New Albany Planning Commission Agenda
Monday, September 18, 2023 7:00pm

FDP-77-2023 Final Development Plan

Re: Credit Union Crimson
Coffee - FDP
2nd Submittal

DATE
08/18/2023
JOB NO.
29580-0002
SHEET
SITE LAYOUT PLAN
C1.00

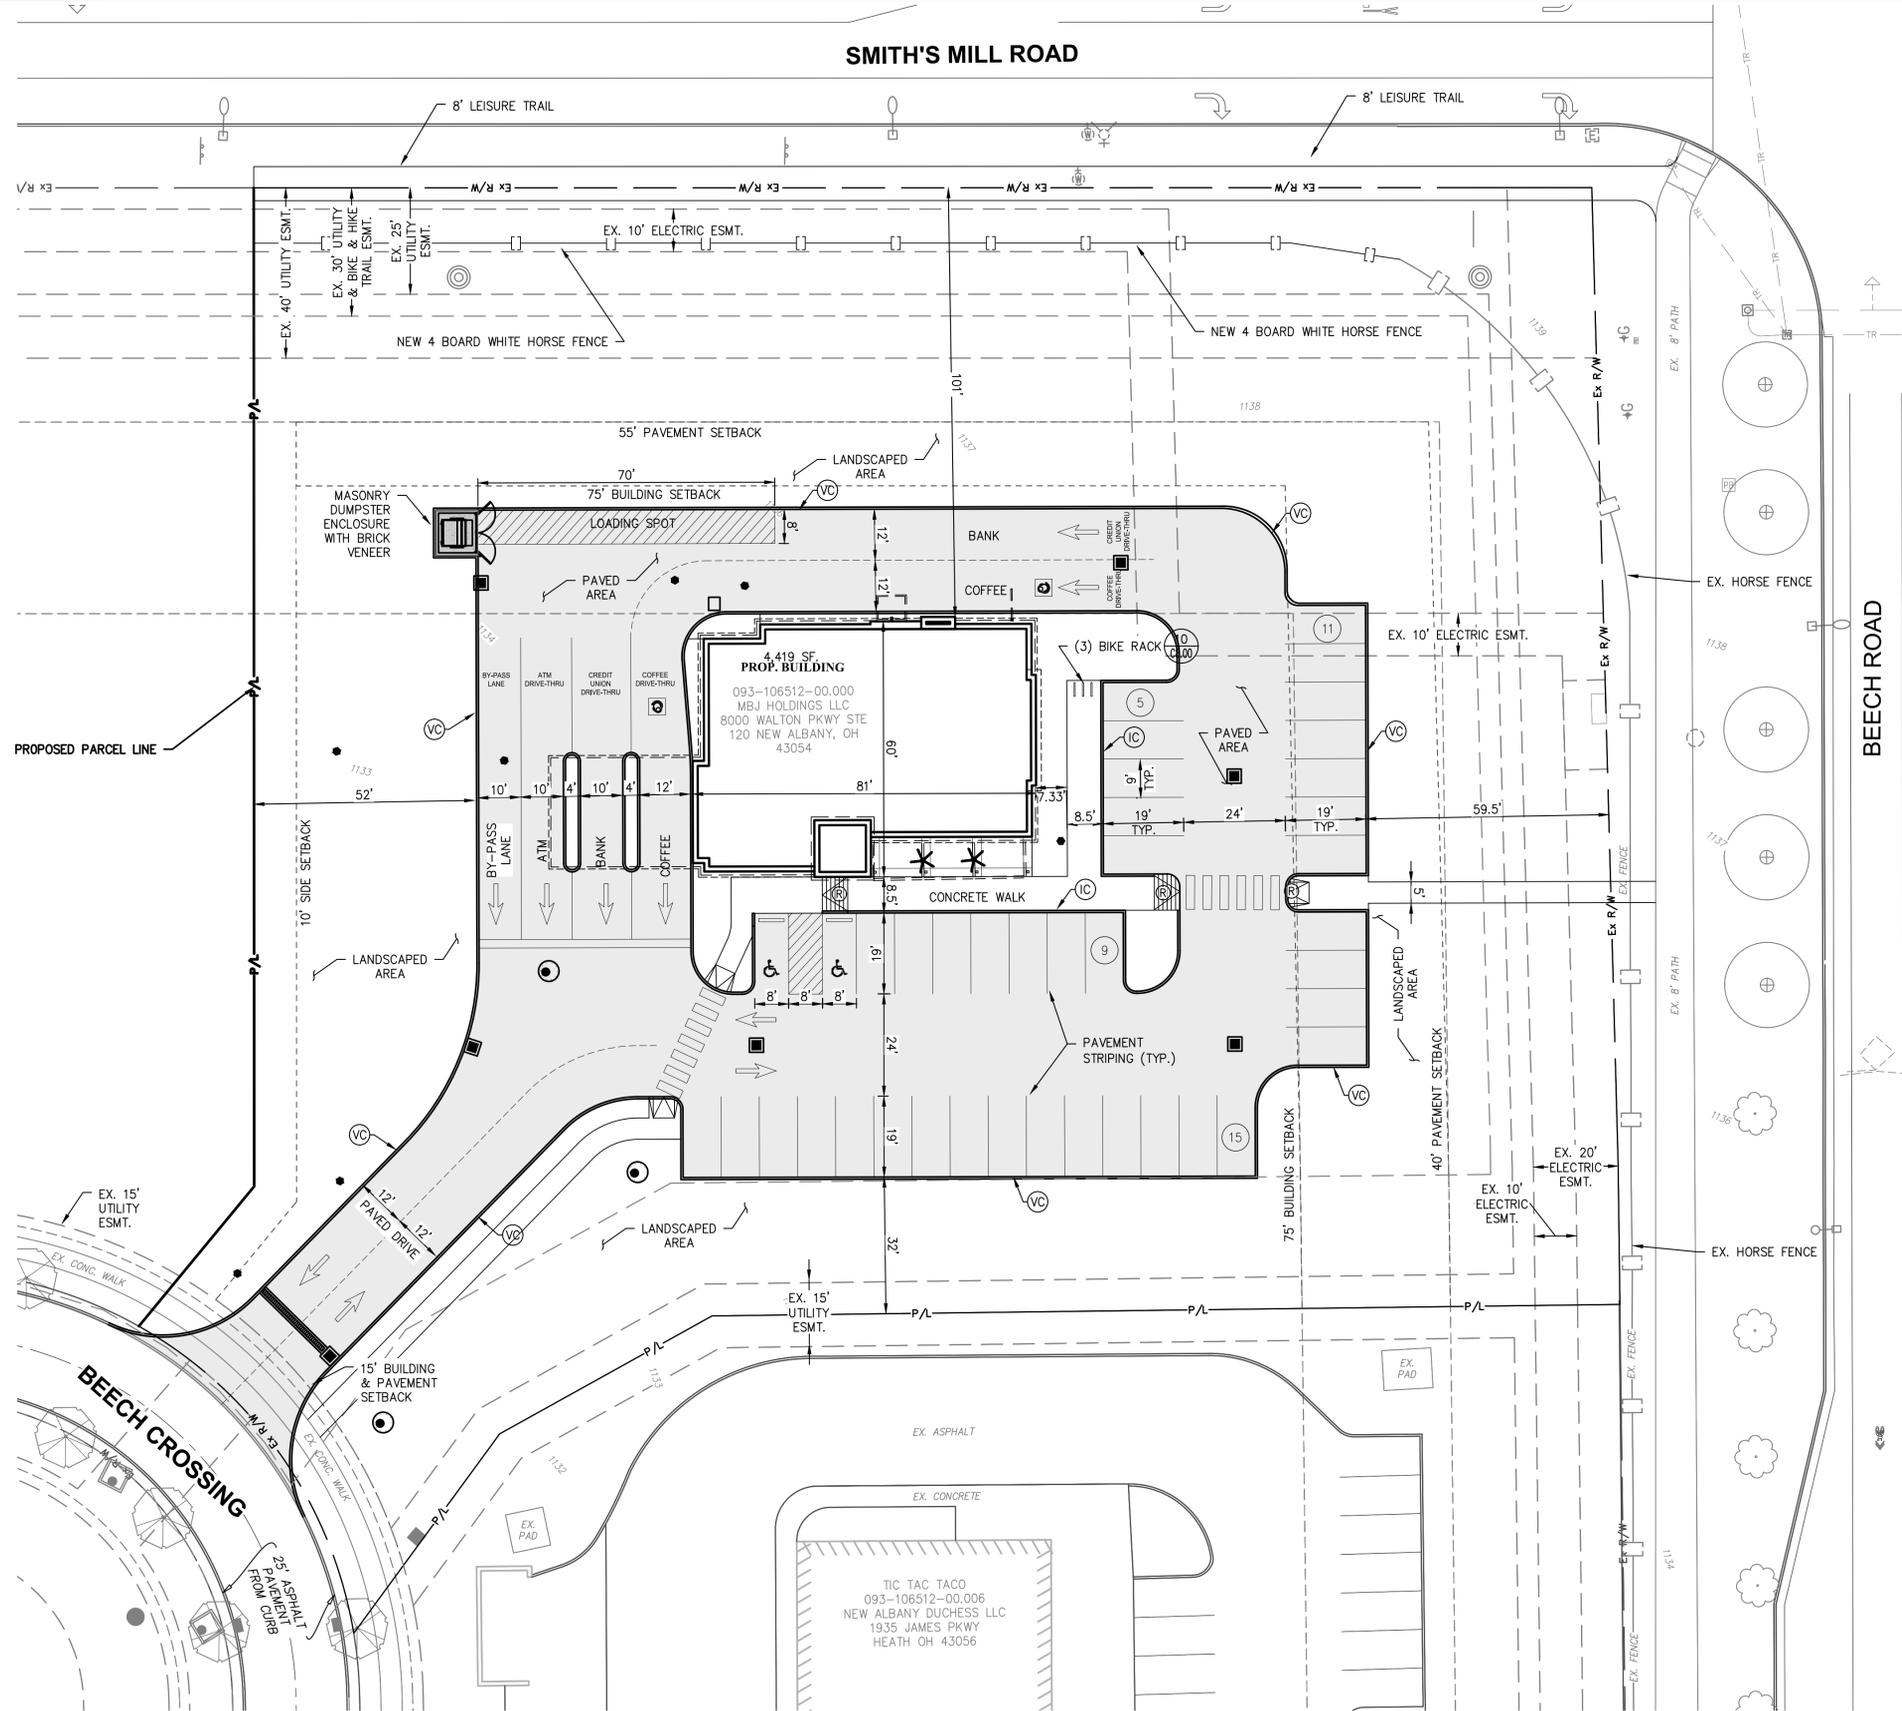
1. Refer to Exhibit A. Revise the referenced FDP to include the signature block provided with Exhibit A and add all note blocks.
2. Refer to sheets C1.00 and C2.00. Show the location of the stop bar and stop sign at the curb cut and provide a cross walk and signage that meets ADA requirements.
3. Refer to sheet L1.00. Provide a site distance triangle at the curb cut and evaluate site distance relative to existing and proposed landscaping. Remove landscaping that may impede motorist view.
4. Provide fire truck turning radius analysis.
5. In accordance with code sections 1159.07 (b)(3) sections Z. and AA. provide documentation indicating that all OPEA or ACOE issues have been addressed.
6. We will evaluate storm water management, water distribution, sanitary sewer collection and roadway construction related details once construction plans become available.

1. Refer to Exhibit A. Revise the referenced FDP to include the signature block provided with Exhibit A and add all note blocks.
2. Refer to sheets C1.00 and C2.00. Show the location of the stop bar and stop sign at the curb cut and provide a cross walk and signage that meets ADA requirements.
3. Refer to sheet L1.00. Provide a site distance triangle at the curb cut and evaluate site distance relative to existing and proposed landscaping. Remove landscaping that may impede motorist view.
4. Provide fire truck turning radius analysis.
5. In accordance with code sections 1159.07 (b)(3) sections Z. and AA. provide documentation indicating that all OPEA or ACOE issues have been addressed.
6. We will evaluate storm water management, water distribution, sanitary sewer collection and roadway construction related details once construction plans become available.
